Tuesday October 8, 2019
Medway Planning and Economic Development Board
155 Village Street
Medway, MA 02053

PUBLIC HEARING - EVERGREEN VILLAGE MULTI-FAMILY HOUSING SPECIAL PERMIT, Site Plan Approval and Scenic Road Work Permit

- Architectural Floor Plan by Anderson Porter Design, A1.1, 9-09-2019, 1 page
- Permit Site Plan by DGT Associates, C-1 thru C-7, 9-09-2019, 7 pages
- Mech. Systems Ventilation and Odor Mitigation Plan by Impact Engineering, 9-12-2019, 17 pages

FIGURE 3. Recommended Noise Control Solutions, Barriers shown in Orange around GRTUs and AHUs

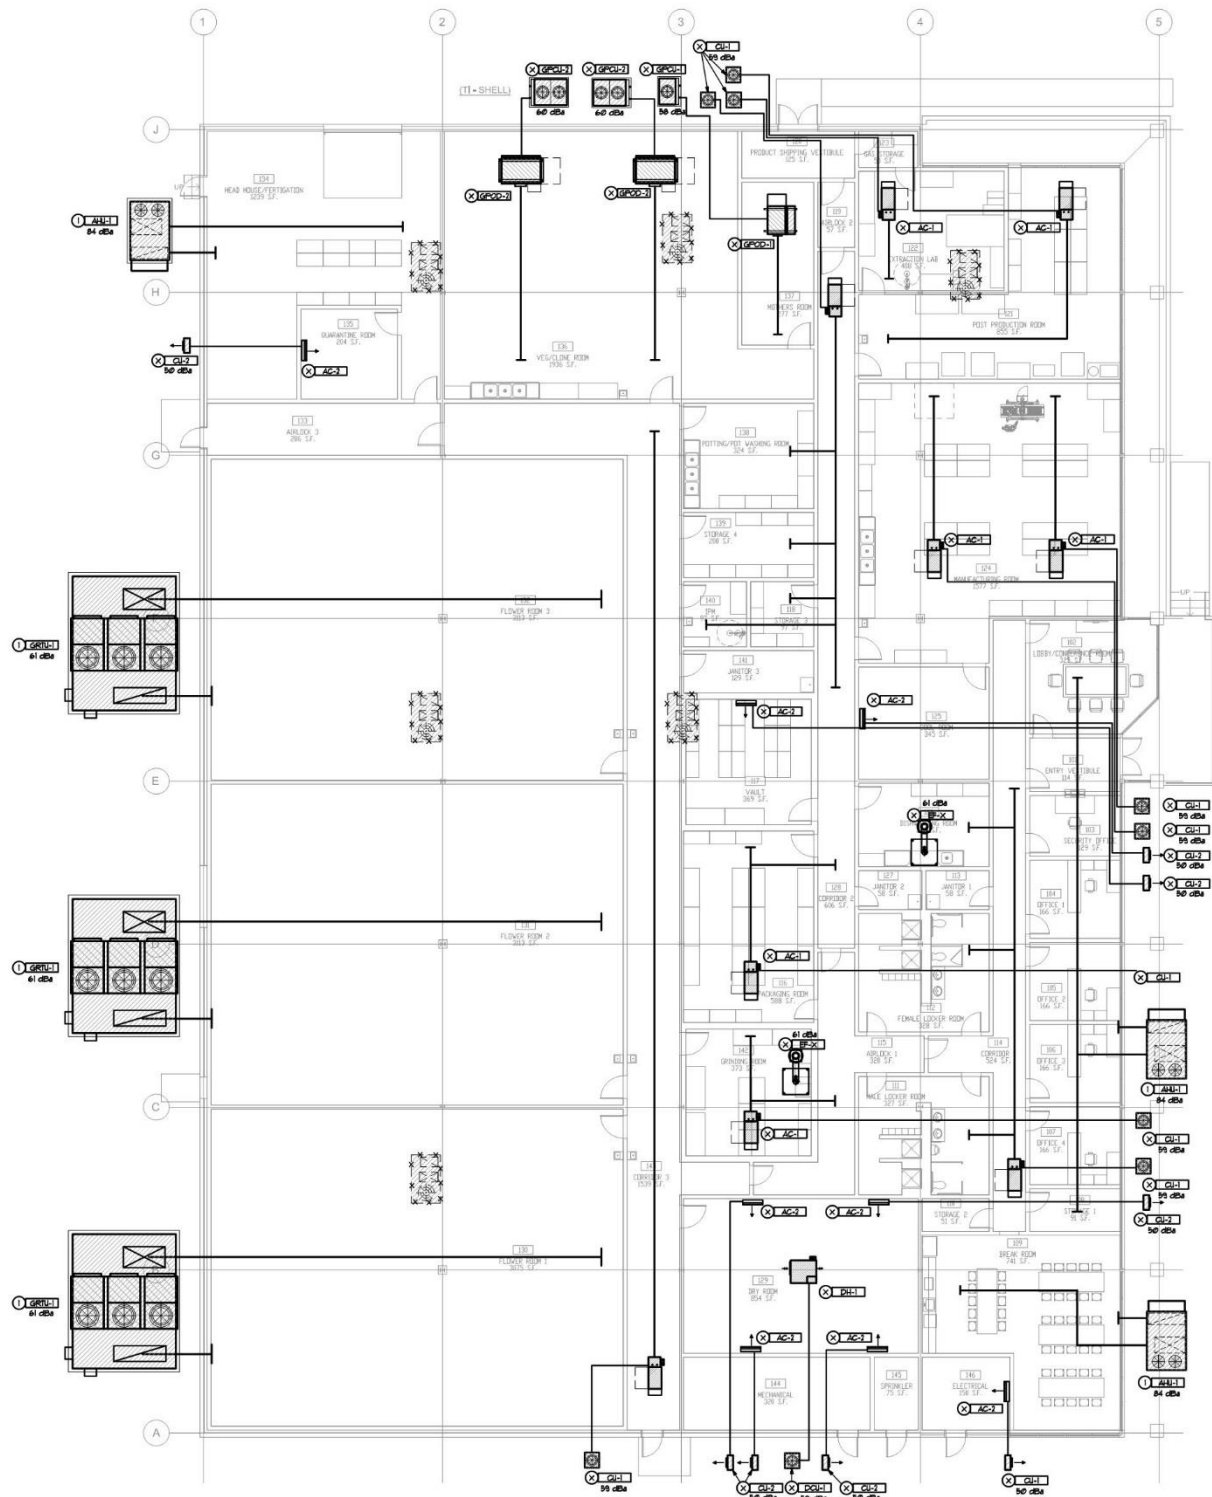
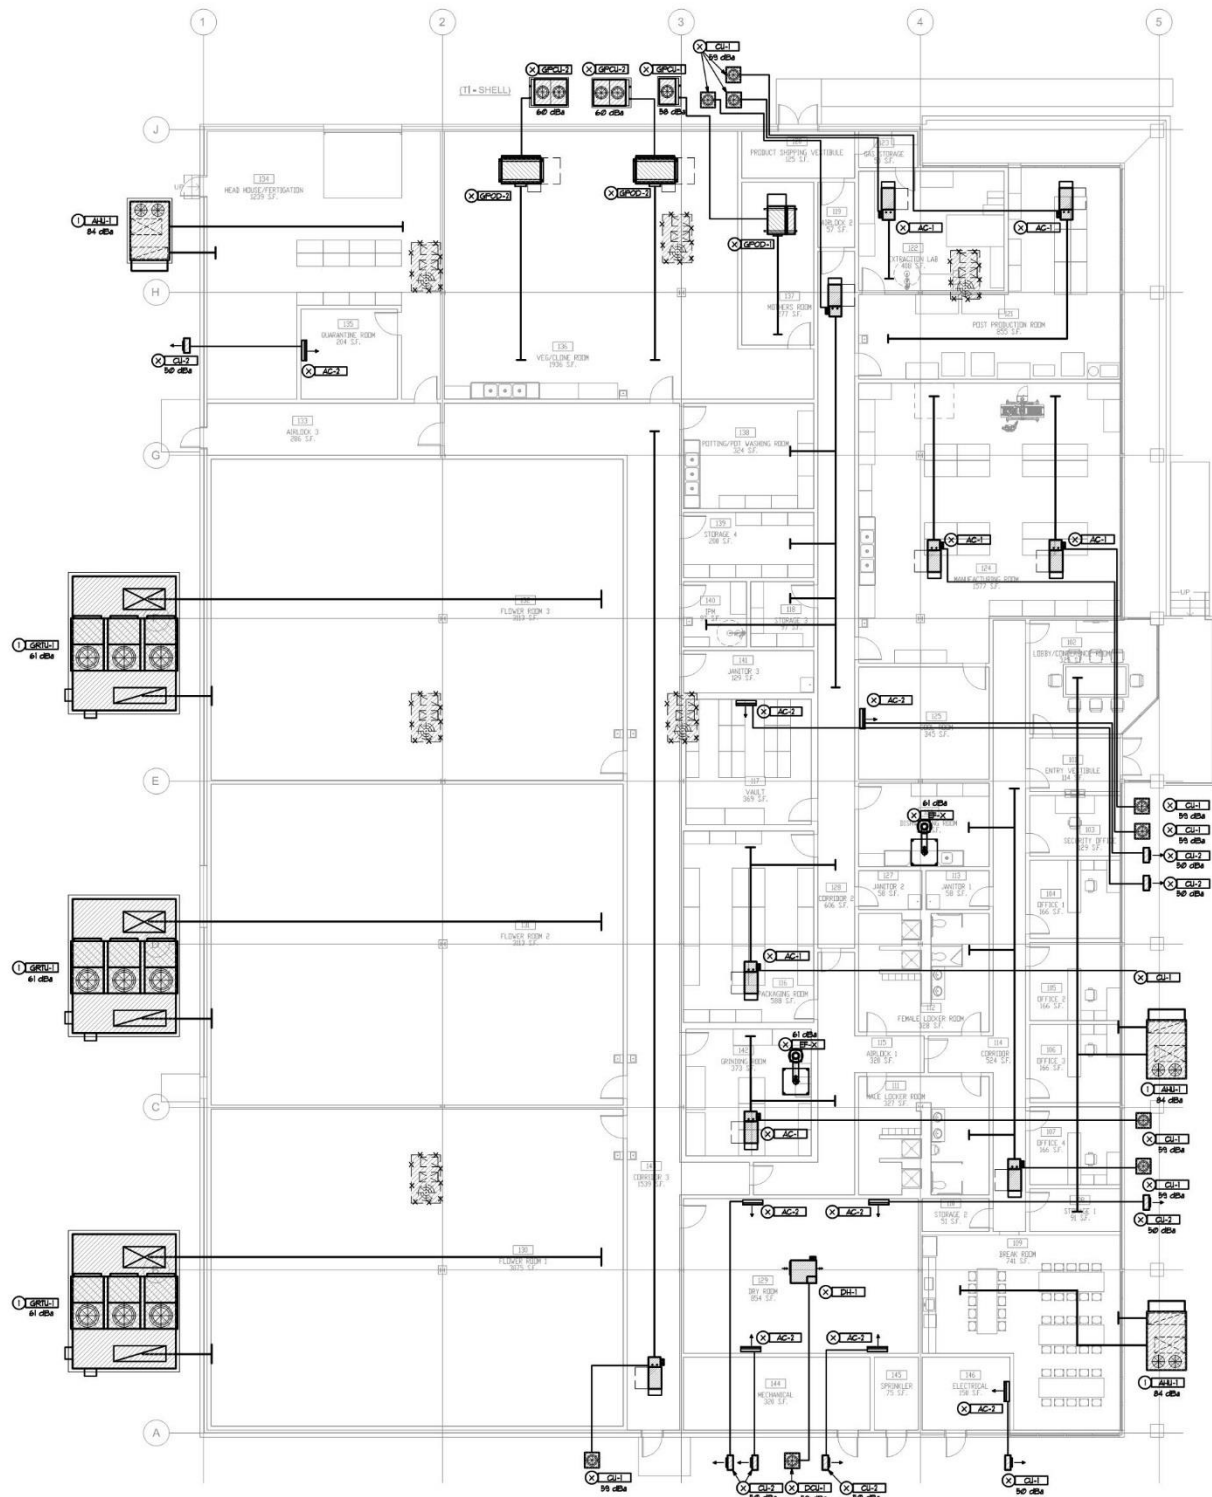
- c. In Figure 3 of Acentechs letter to NEO is a fourth barrier missing for AHU-1 in the West-North corner of the building? (see NEO_Barriers attachment)
- d. Was any consideration given to locating some/all of the GRTU-1's on the industrial side (East) of the building?
 - i. If no, why not?
 - ii. If yes, what were the sound differences at the property lines and residential receptors.

PRELIMINARY SUBDIVISION PLAN
PROPOSED PLAN
CHOATE TRAIL WAY
IN
MEDWAY, MASS.

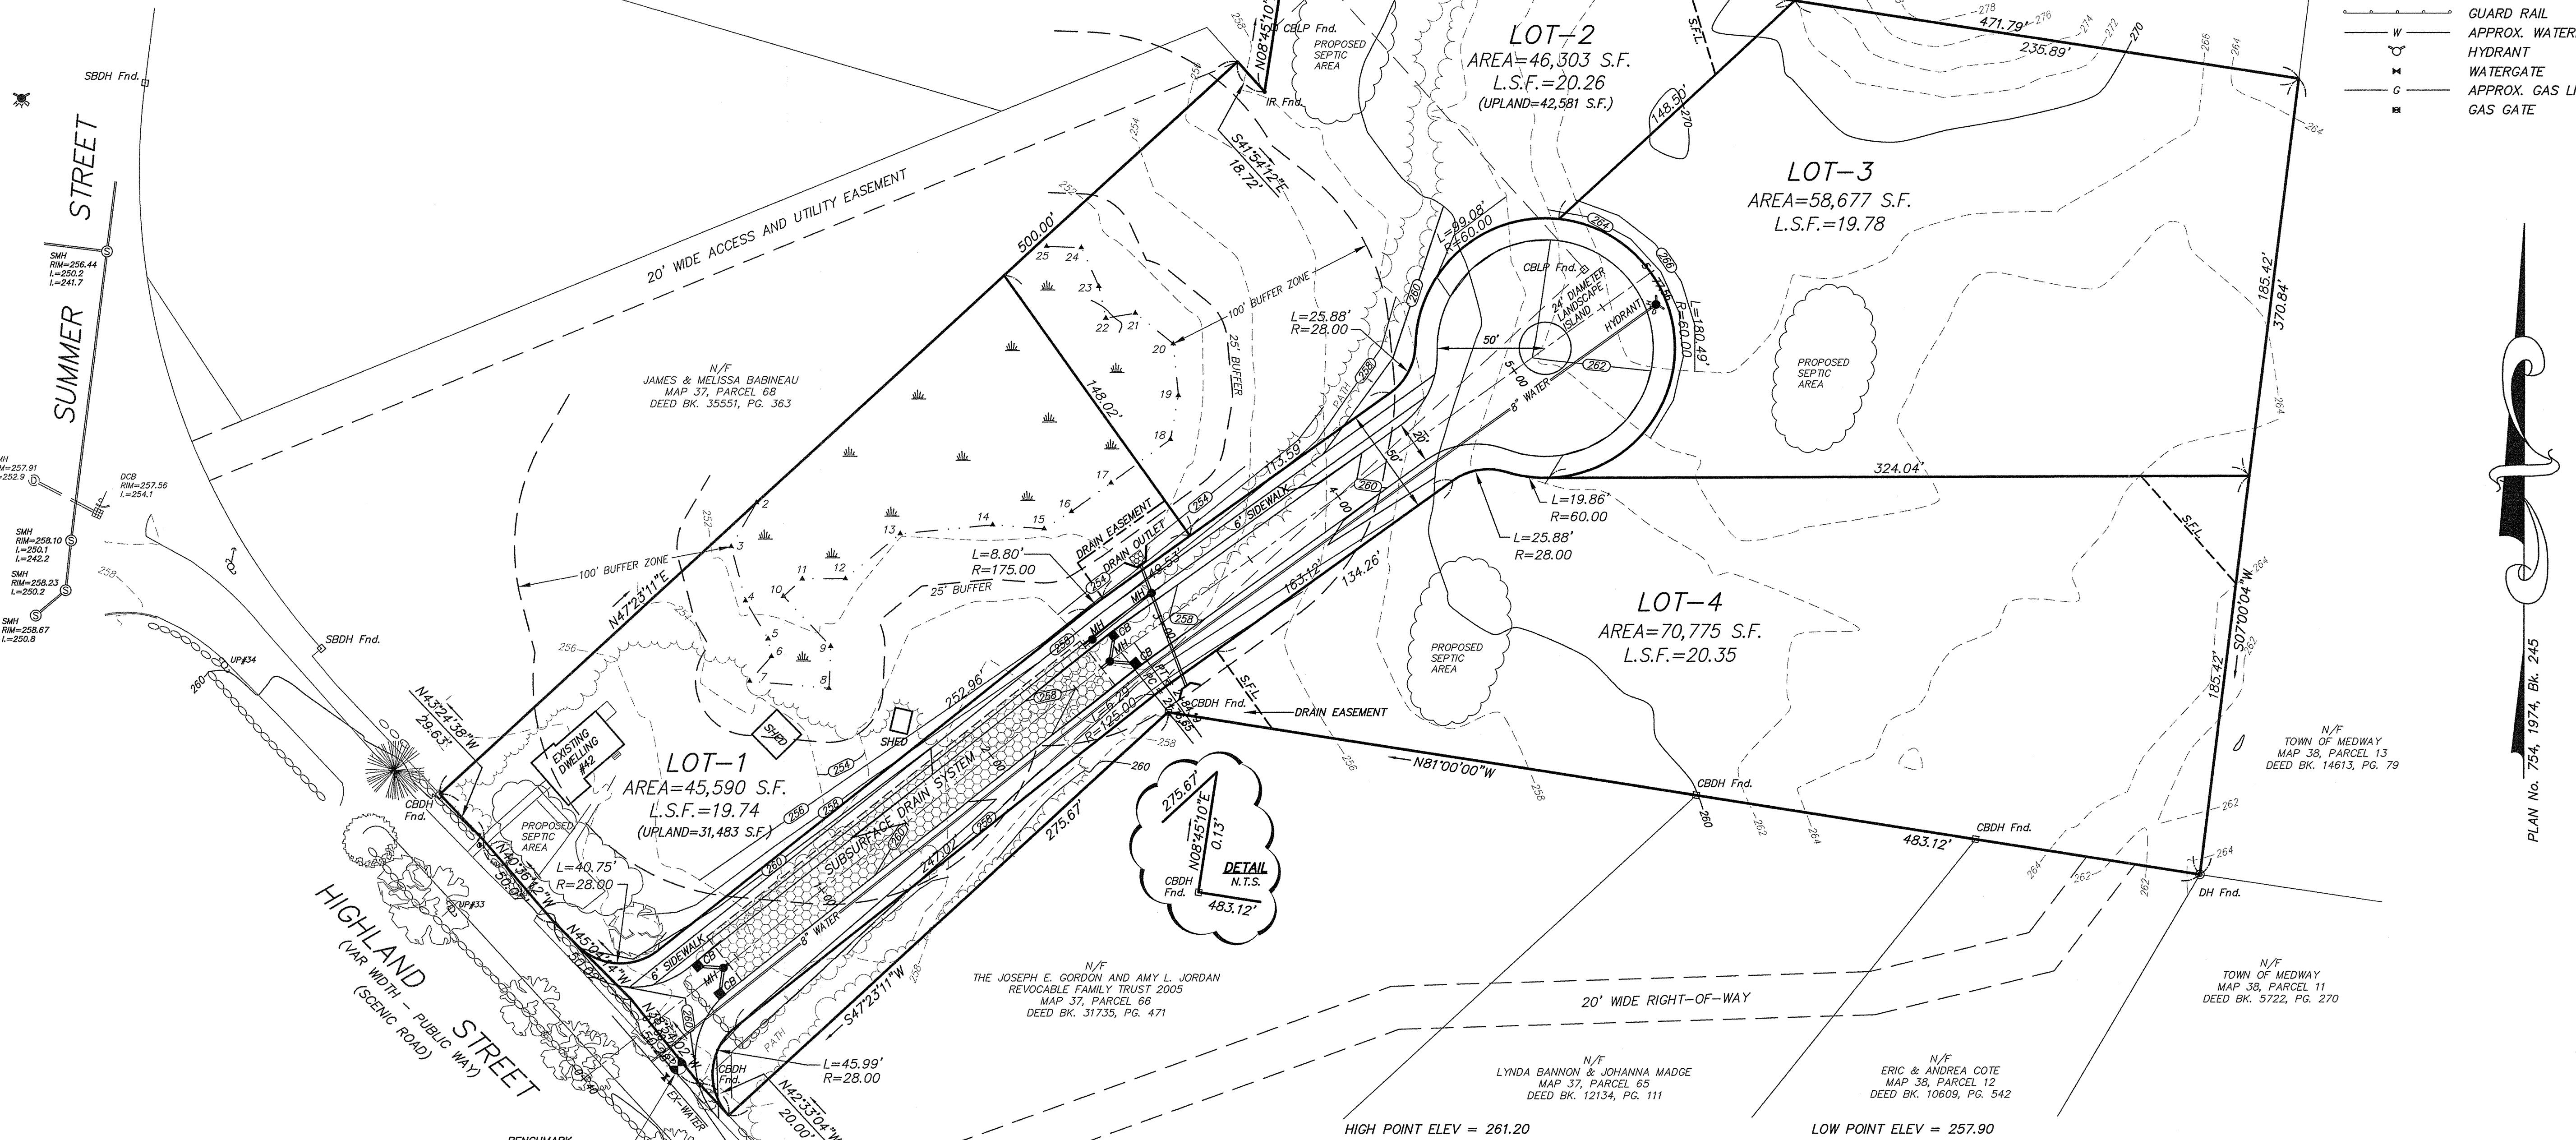
Consultant Carlucci noted that the sidewalk shown does not extend around the perimeter of the cul-de-sac as required. It was also communicated that the subdivision should provide an extension to abutting undeveloped land. However, the Town of Medway owns the abutting land so a roadway extension is not necessary but a pedestrian pathway to provide access to the High School and through to the Choate Park trail should be considered. Highland Street is a scenic road and it was recommended to use the existing rocks for rebuilding of the wall.
